REMARKS

Claims 10-11, 15, 25-26, 30-58, 62, and 66-80 are now pending in the application. Claims 1-9, 12-14, 16-24, 27-29, 59-61, and 63-65 have been canceled without prejudice or disclaimer. The specification, drawings, and claims 10, 15, 25, 30, 31, 34, 41, 62, and 66 have been amended, and new claims 77-80 added, without introduction of new matter. Favorable reconsideration is respectfully requested in view of the above amendments and the following remarks.

FIG. 3

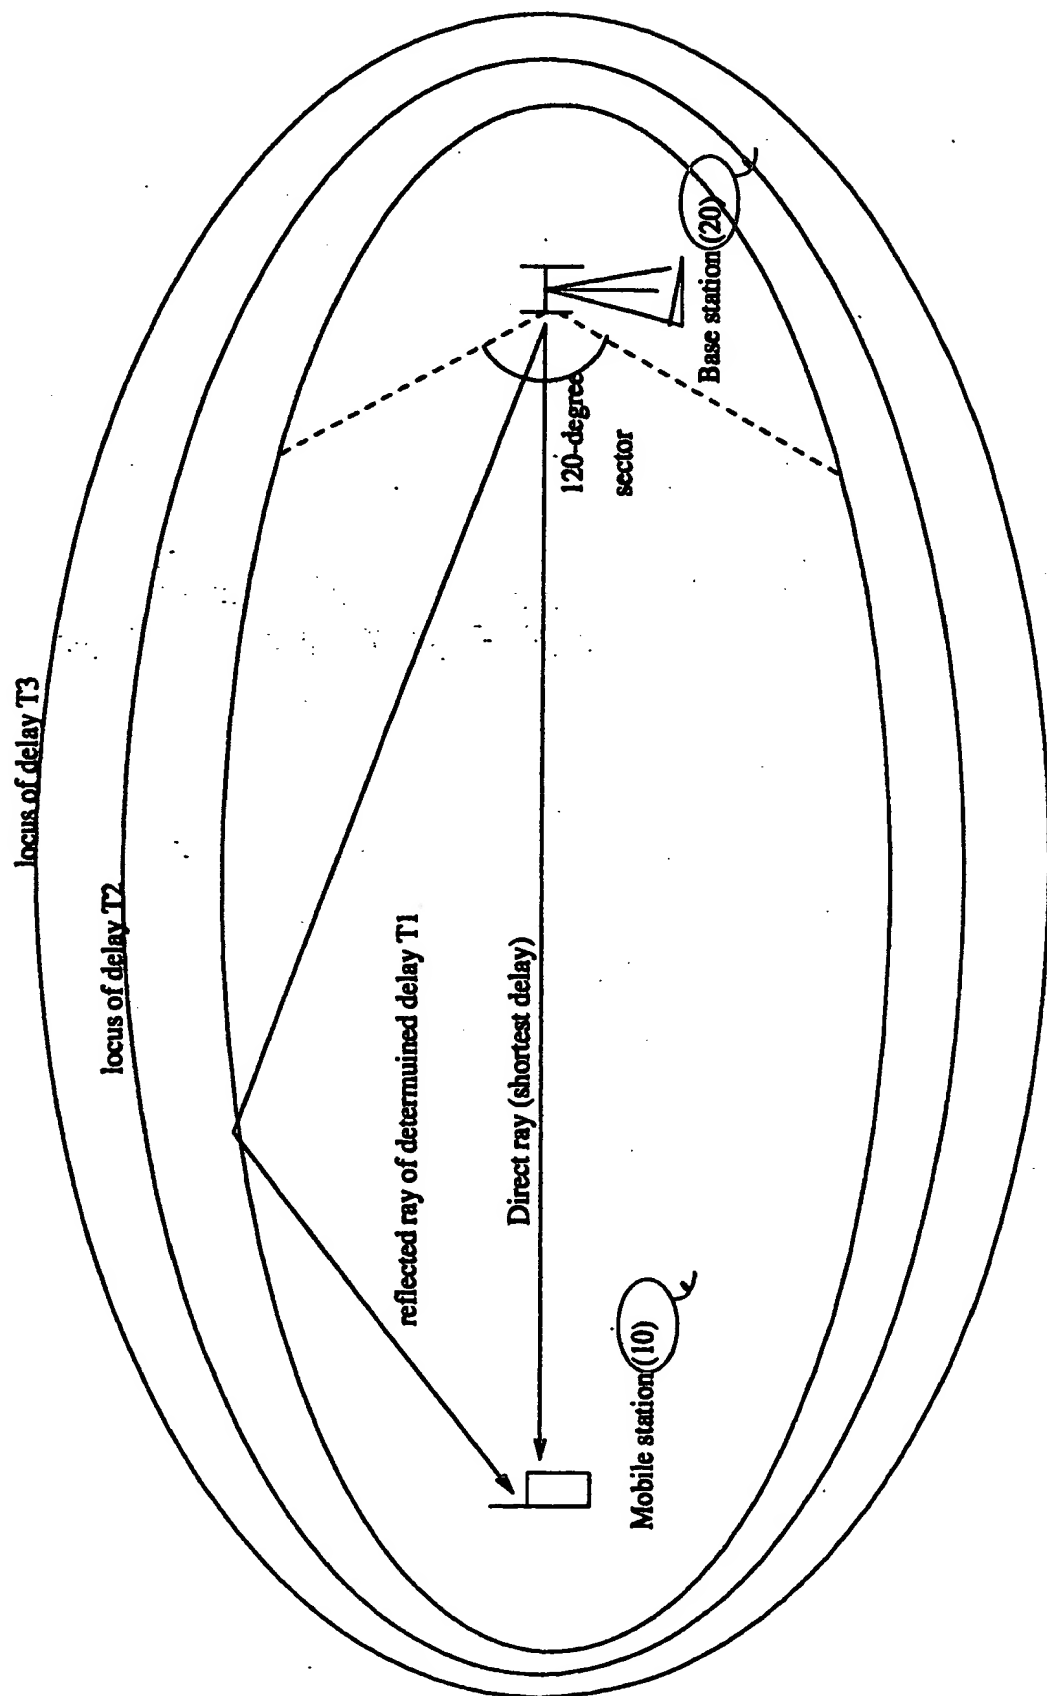
Regarding Fig. 3, the Office objected that reference numerals 10 and 20 are not mentioned in the description. In response, Fig. 3 is now amended to remove reference numerals 10 and 20.

FIG. 6

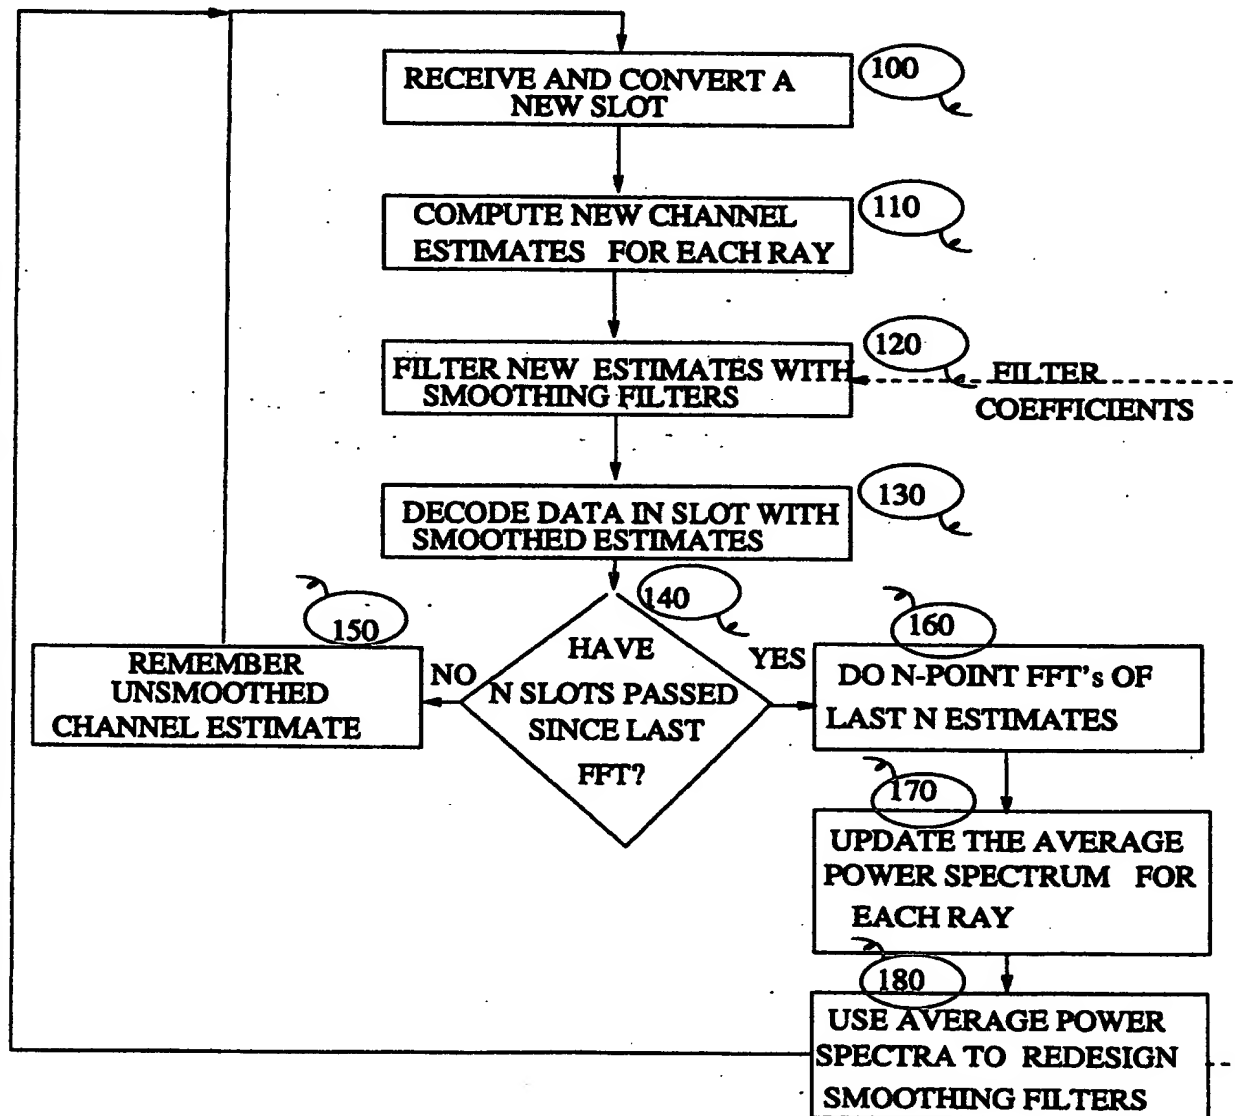
Regarding Fig. 6, the Office objected that reference numerals 100, 110, 120, 130, 140, 150, 160, 170, and 180 are not mentioned in the description. In response, Fig. 6 is now amended to remove these reference numerals.

FIG-10

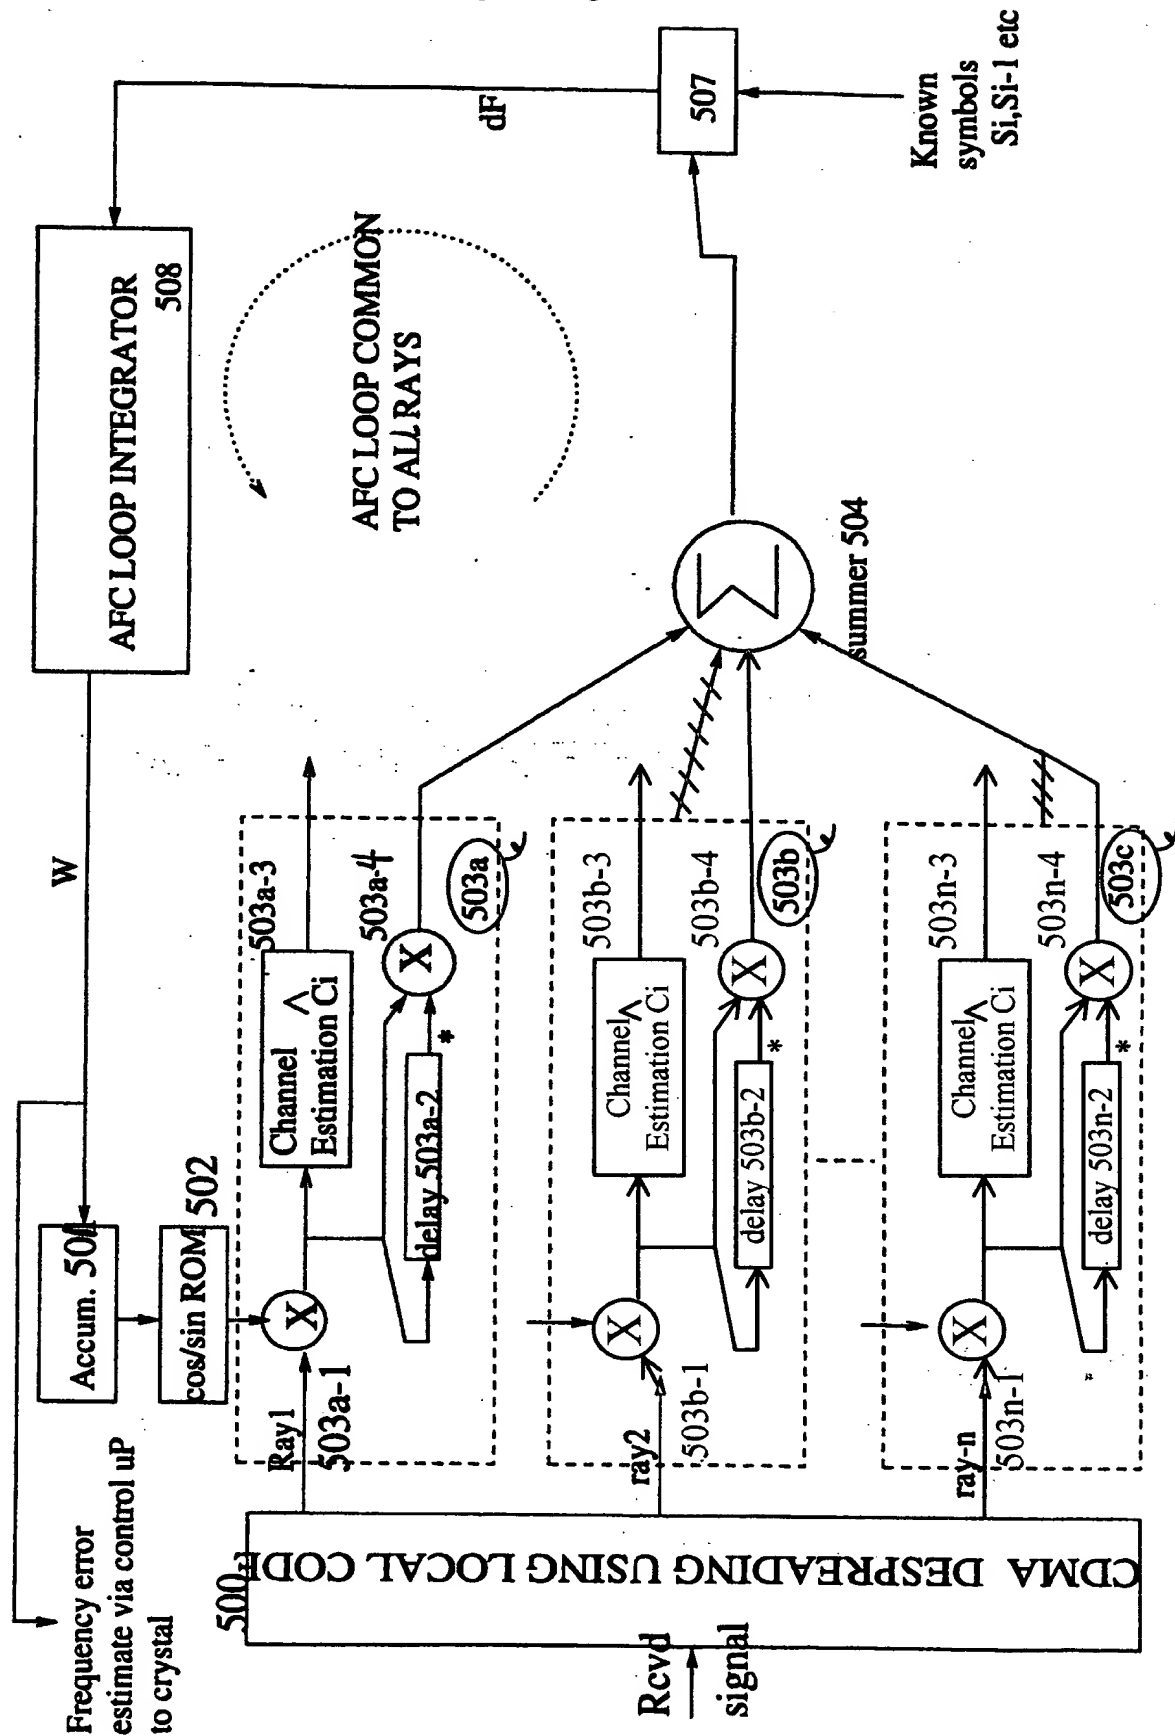
Regarding Fig. 10, the Office objected that reference numerals 503a, 503b, and 503c are not mentioned in the description. In response, Fig. 5 has been amended to remove these reference numerals.

The drawings were further objected to for allegedly not including the following reference signs mentioned in the description: reference characters 503b-1 – 503b-4, 503n-2 – 503n-4 in Fig. 10, and reference character 508-1 in Fig. 15A.

In response, Fig. 10 has been amended, without introduction of new matter, to expressly include the elements referred to by reference characters 503b-1 – 503b-4, 503n-2 – 503n-4, and of course to include these reference characters themselves.
